3. SIGNAGE

City of Sydney Comment - 3 a)

Figure 11: Pier 2/3 western signage. Proposed signs shown red for clarity.

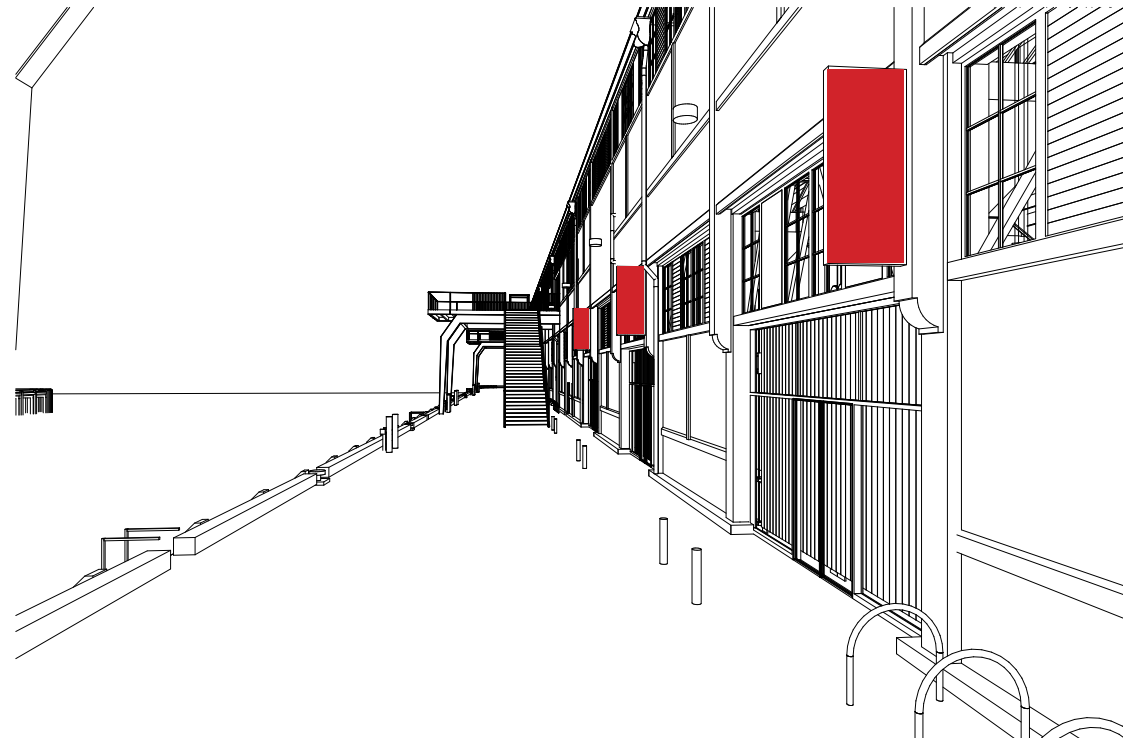
Details of the new proposed signs shown in Figure 27 (red lines marked as “signage location”) are unclear. There are a substantial number of these signs and there is a potential for clutter depending on the purpose, size, design and location of these signs.

A revised signage plan is included on the following page, rationalising the number of tenant identification signs internal to the Precinct. The proposed signage locations and sizes are shown on the plan overleaf and the perspectives adjacent. The signs have been sized to relate to the original fabric of the wharves and are indicated in red for clarity, with the proposed digital walls marked orange.

Figure 16: Wharf 4/5 Breezeway Digital Wall location

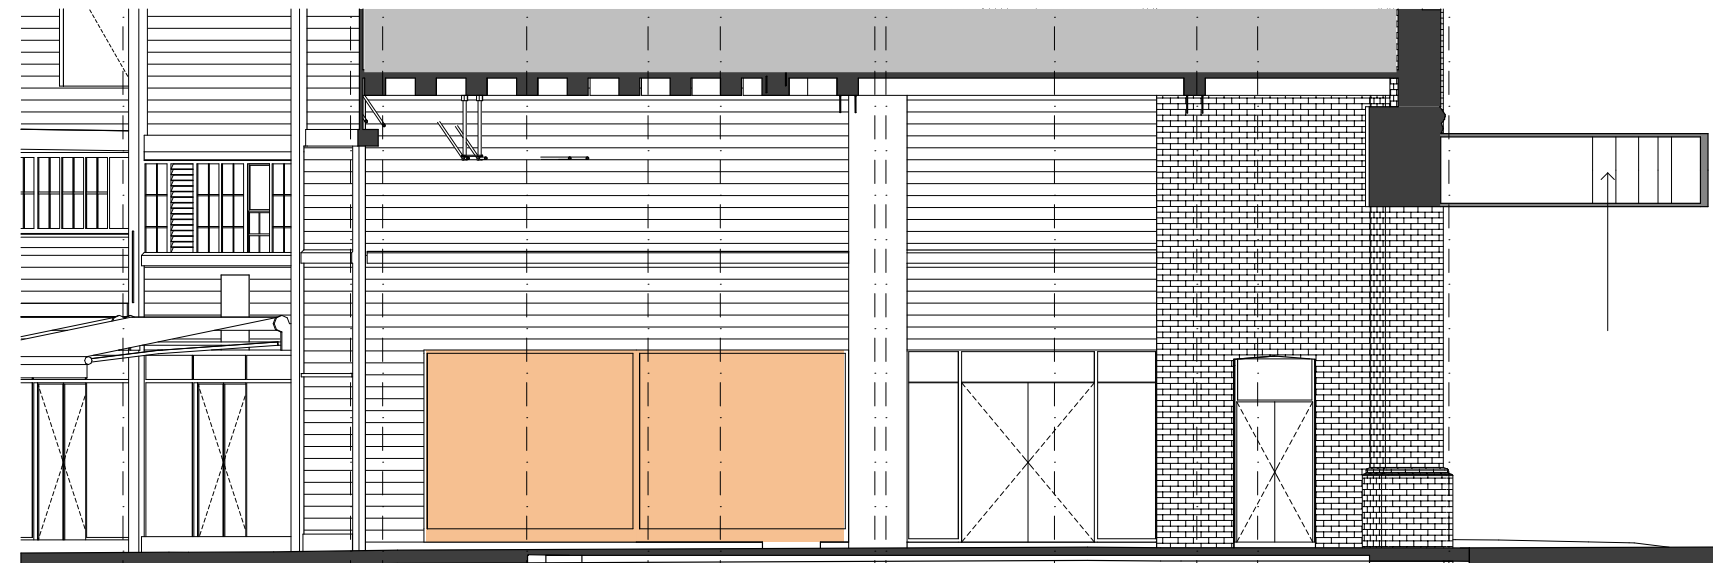
No details of the 'new digital walls' included in Figure 27 are provided. Details such as the size of these elements as well as their fixings to the wharf building fabric are required. Fixings should avoid significant heritage fabric and be reversible.

New 'digital walls' are proposed in the Shoreshed 4/5 Breezeway 1, adjacent the Visitor Portal and on the southern wall of the Pier 2/3 Colonnade. The final size of these digital elements will be developed in detailed design in consultation with the City of Sydney and Heritage Council, however, Figures 16 and 17 to the right indicate the areas where digital walls are proposed and the design intent. The fixings will be developed in a manner to minimise any impacts on heritage fabric and be reversible.

Figure 18: Hickson Road awning sign indicative section

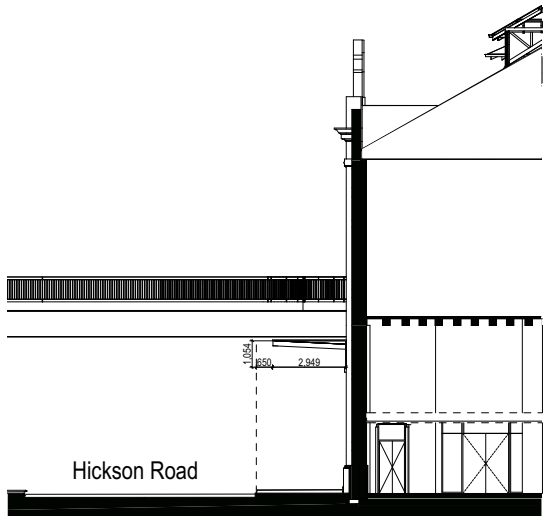
The proposed digital awning signs as shown in Figures 12 and 13 indicate they have a minimal projection however, Figures 19 and 20 show them as substantial projecting awnings, though dimensions are not annotated. The awnings should be sized to allow a margin around them, enabling a reading of the rendered surface on which they are affixed. They should be set in from each side by approximately 200mm for the same reason.

The Applicant will develop the detailed design of the signage and wayfinding in consultation with the Heritage Council and City of Sydney. This will include consultation in relation to the sizing of the awnings. The Applicant commits to ensuring that the awnings will be designed to enable a reading of the rendered surface to which they are affixed.

Figure 20: Pier 2/3 bridge sign west elevation

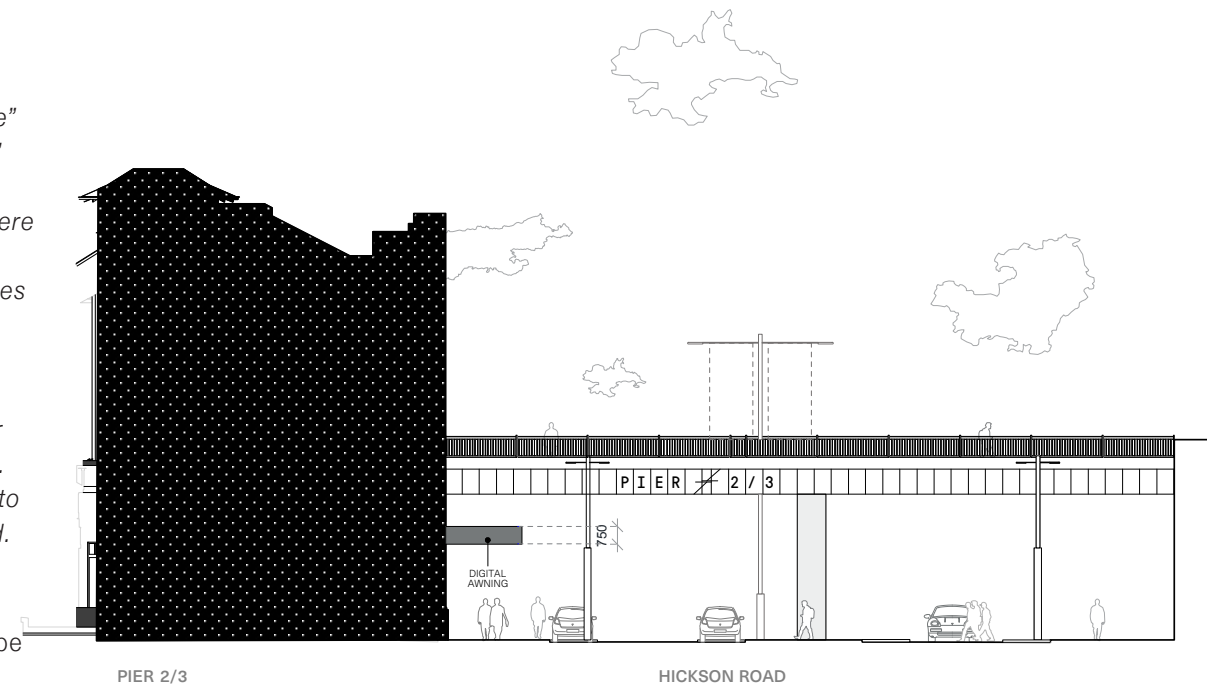
Figures 19 and 20 illustrate signage across the viaduct bridges akin to "The Goods Line" signage. This is supported for the 'Pier 2/3' and 'Wharf 4/5' signs as these are place based signs, as is The Goods Line sign. There is some concern that the other proposed bridge signs are for dance/theatre companies that may come and go to the precinct. The signage strategy should speak to the removal / replacement of these signs. The signage is designed for the present number of companies, with particular name lengths. Removal of parts of the sign over time due to the loss of a company should be addressed.

The Applicant confirms that there will only be place based signage on these structures.

Refer to revised Figures 20 and 21 adjacent.
